**Rezoning from "Residential (Group C) 2" and "Open Space" zones to
"Residential (Group C) 4" zone for a Proposed Residential Development
at Lot Nos. 519 RP (part) and 520 RP in D.D. 110 and adjoining Government land,
Shek Kong, Yuen Long, N.T.
and
Rezoning from "Residential (Group C) 2" to "Open Space" zone
at Lot Nos. 121, 137, 138, 139 S.A and 139 RP (part) in D.D. 110
and adjoining Government land, Shek Kong, Yuen Long, N.T.
(S12A Amendment of Plan Application No. Y/YL-KTN/6)
- Further Information No. 1 -**

Proposed Rezoning of the Application Site from (i) “Residential (Group C) 2” and “Open Space “ Zones to “Residential (Group C) 4” Zone for a Proposed Residential Development at Lot Nos. 519 RP (part) and 520 RP in D.D. 110 and adjoining Government land and (ii) from “Residential (Group C) 2” to “Open Space” Zones at Lot Nos. 121, 137, 138, 139 S.A and 139 RP (part) in D.D. 110 and adjoining Government land at Shek Kong, Yuen Long, N.T. (S12A Amendment of Plan Application No. Y/YL-KTN/6)

Comments Forwarded from Fanling, Sheung Shui and Yuen Long East District Planning Office

Site Location

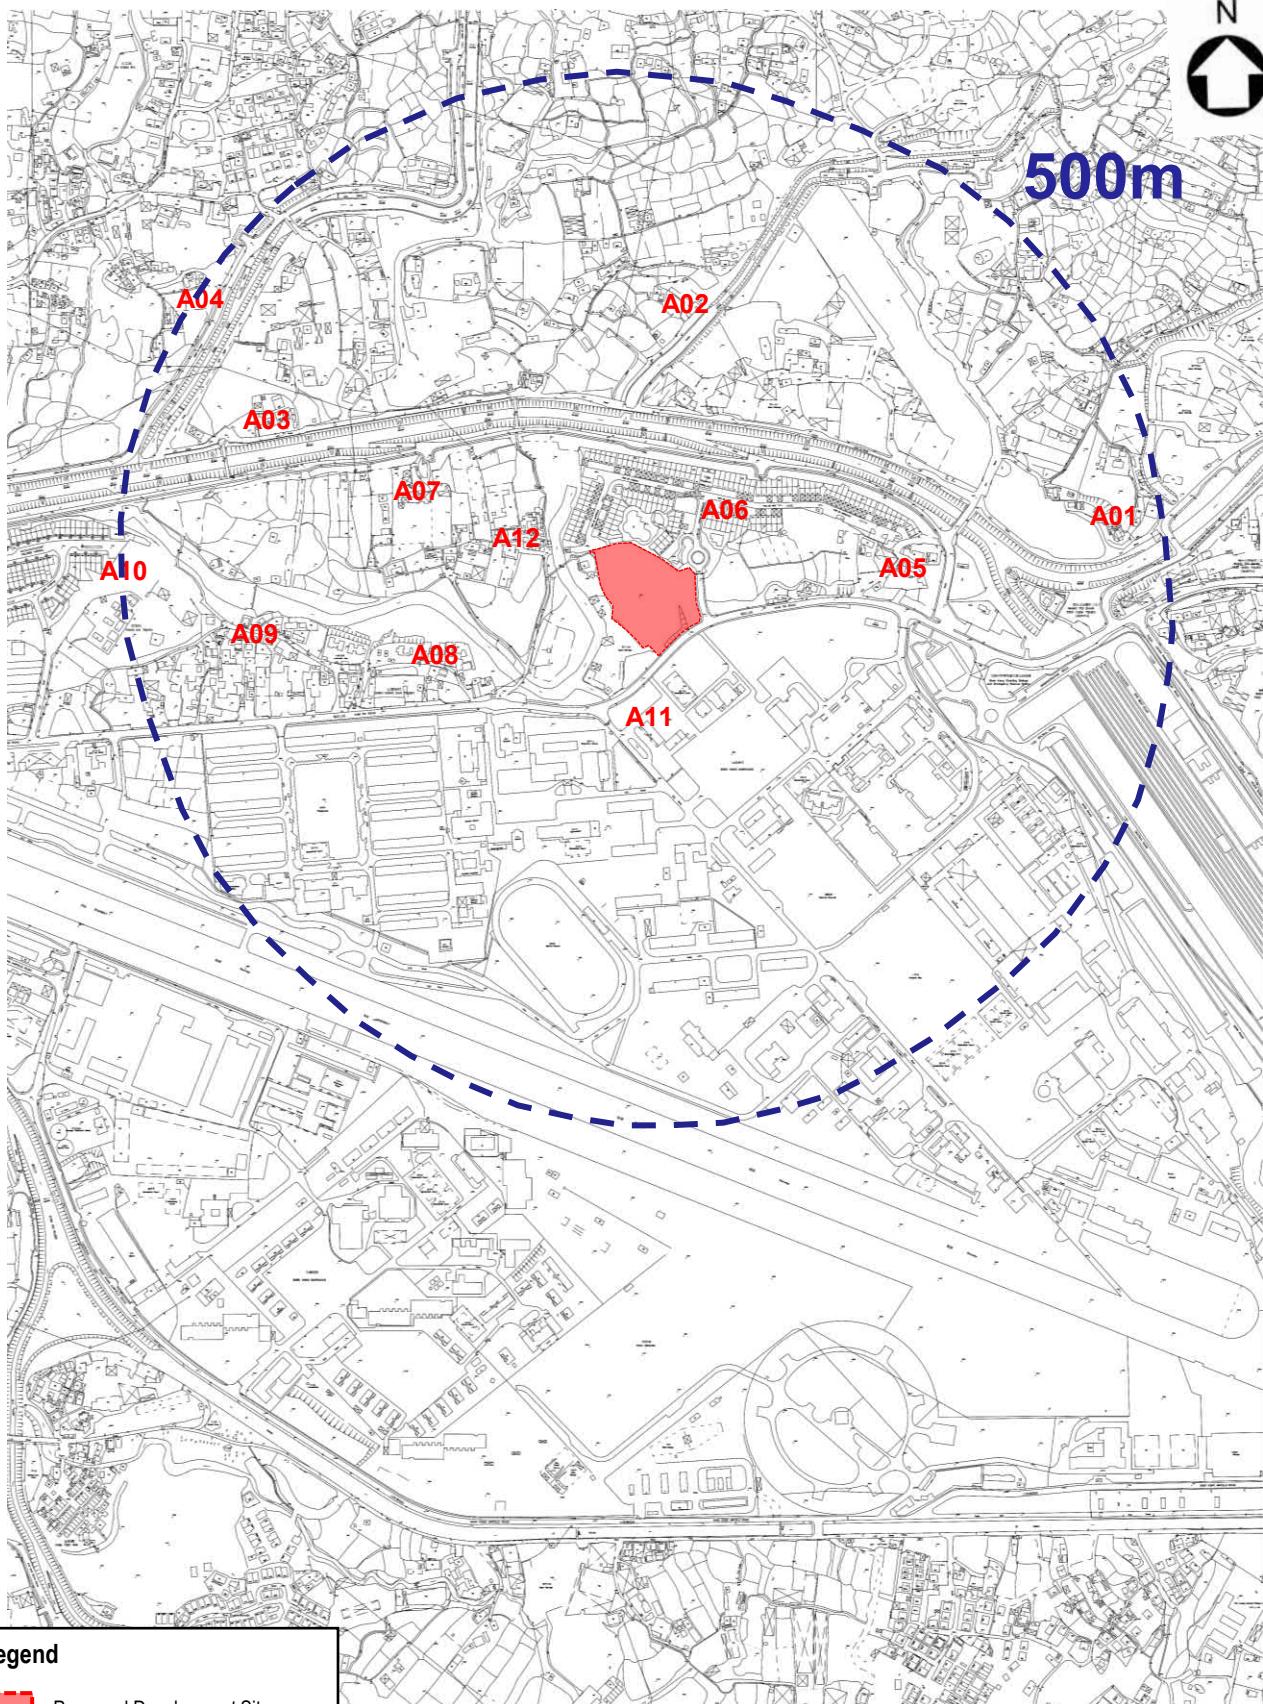
Comments	Responses
10. Figures 1, 2 and 5a - The assessment area should be 500m measured from the boundary of the project site, thus it should not be a circle. Please revise.	Figures 1, 2 and 5a are revised. The assessment area is now drawn according to the 500m area generated by the SAMP v2.1.
<p>Noise Impact Assessment</p> <p>1. As the development layout for the proposed development is for indicative purpose only and the Applicant has committed to submit an updated Noise Impact Assessment under the land administration mechanism to cater for any possible changes in the development layout at a later stage during the pre-submission enquiry, please suitably document such commitment in the Noise Impact Assessment (NIA) for the subject s.12 planning application. Subject to the incorporation of such commitment in the NIA, please take note of the following advisory comments when preparing an updated NIA under the land administration mechanism:</p> <p>a. Please seek TD's endorsement on the traffic forecast. In case TD has no comment on the methodology for traffic forecast only, the consultant should provide written confirmation from the respective competent party (e.g., traffic consultant) that TD's endorsed methodology has been strictly adopted in preparing the traffic forecast data, and hence the validity of traffic data can be confirmed.</p>	<p>Noted.</p> <p>TD's endorsement on the traffic forecast will be provided once available.</p>
